# Broadcast Products Technical Bulletin 20-2015-109

DATE: **June 8, 2015**SUBJECT: **SOFTWARE UPGRADE—VERSION 2.02**MODEL: **CA4000**  
**CA4000****DESCRIPTION**

Software version 2.02 is available.

Figure 2

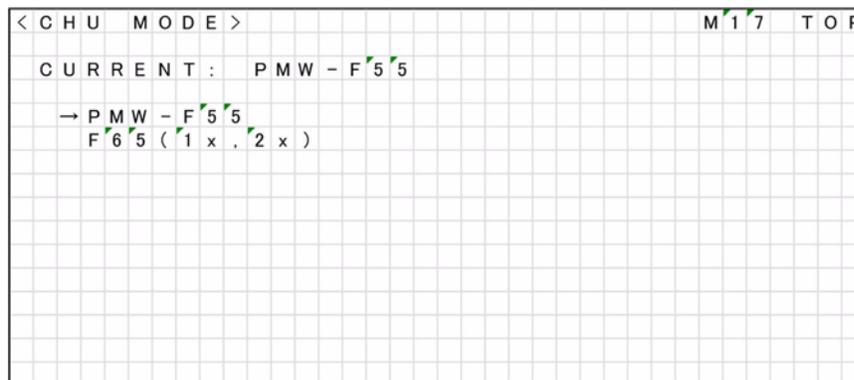
When the camera connected is changed between PMW-F55 and F65, set CA4000 > MAINTENANCE > CHU MODE to the appropriate camera connected, then set CHU MODE in BPU accordingly. (See Figure 2.)

**NOTE:** If the camera setting for CHU MODE does not match the camera setting for CHU MODE in the BPU, the warning message "PLEASE CONFIRM CHU MODE ON BPU" appears on the BPU menu.

**Figure 3**

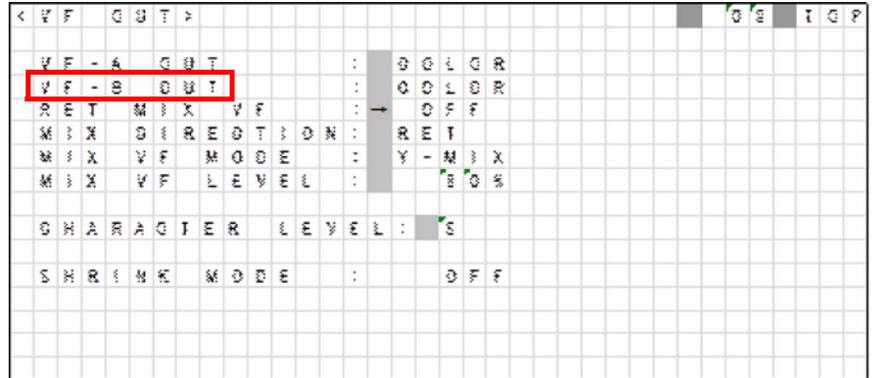
The monochrome indication on DVF is supported. (See Figure 3.)

CA4000 Operation menu > VF OUT > VF-B OUT >  
COLOR/MONO
